Date of Issuance: 05/09/2024	Effective Date: 09/14/2023
Owner: Town of Pendelton	Owner's Contract No.: #219091-21-049G
Contractor: Sicoli Construction Services, Inc.	Contractor's Project No.:
Engineer: Nussbaumer & Clarke, Inc	Engineer's Project No.: 22J1-0123
Project: Town of Pendelton Community Center	Contract Name: General Construction Contract

Description:
This Change Order is in reference to:
Change Request #30 - Ruff Cut Timber Truss at Carport-Building Connection

Re: Town of Pendleton Community Center
SCS Job #198, **CR#30**

Change order for ruff cut timber truss

CARPORT @ WALL DETAIL
SCALE: 3/4" = 1'-0"

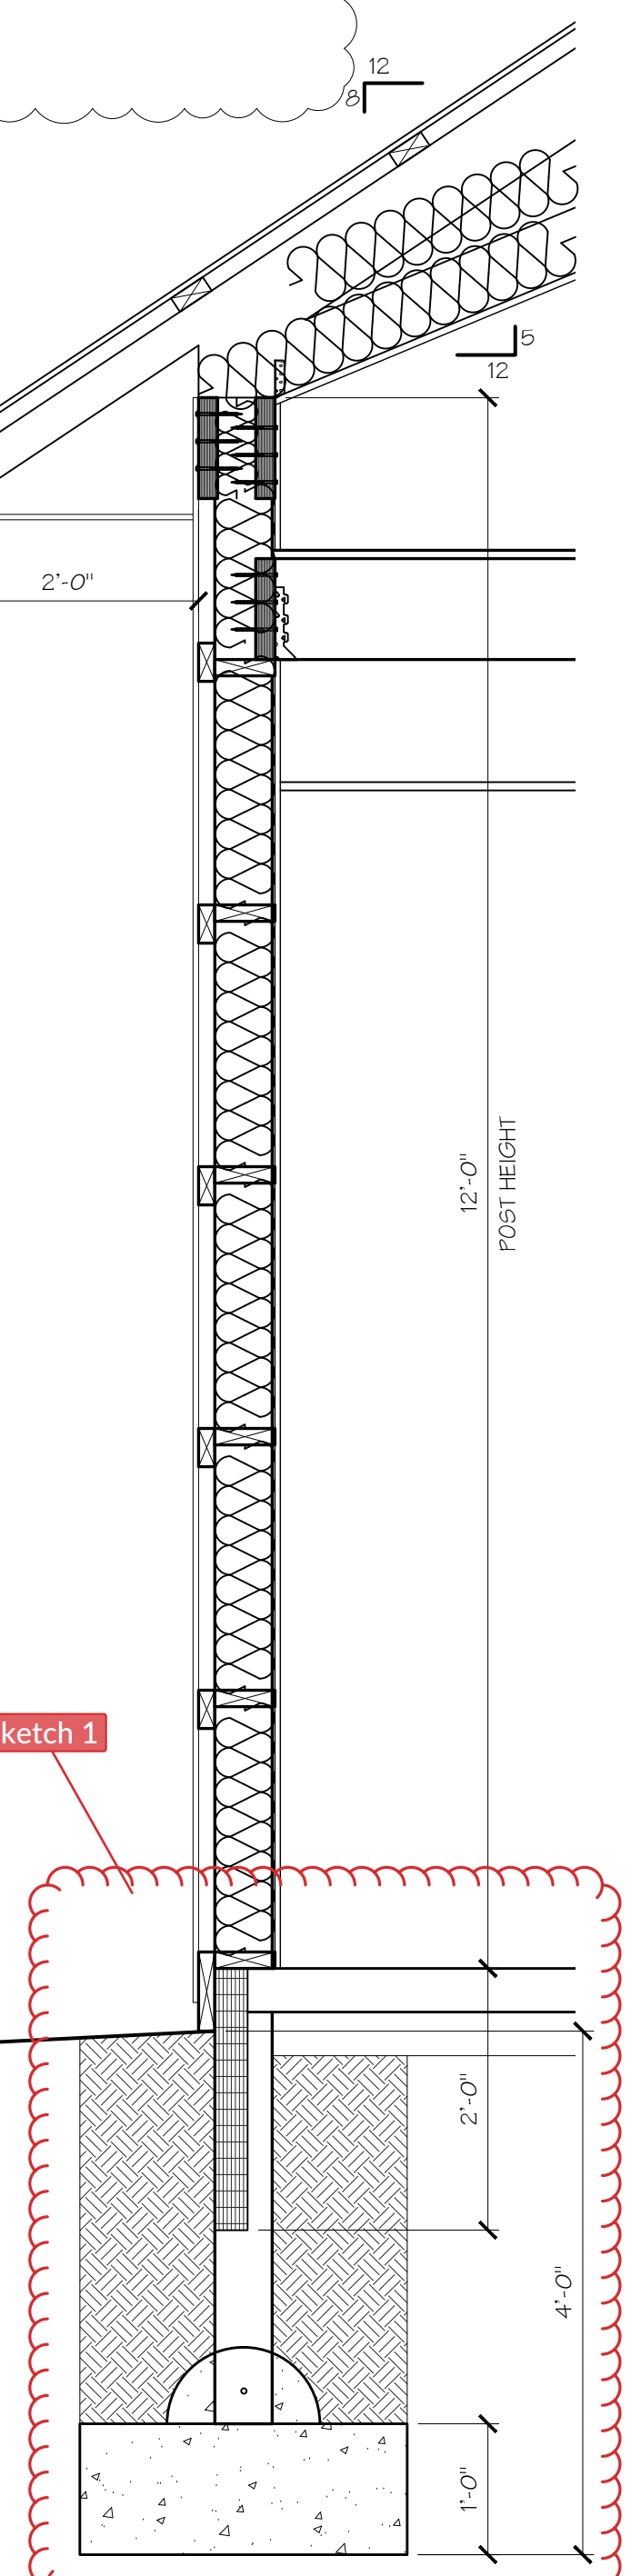
Per your request, to provide and install ruff cut timber lumber/truss at carport building connection, we hereby submit the following quotation for Change Order:
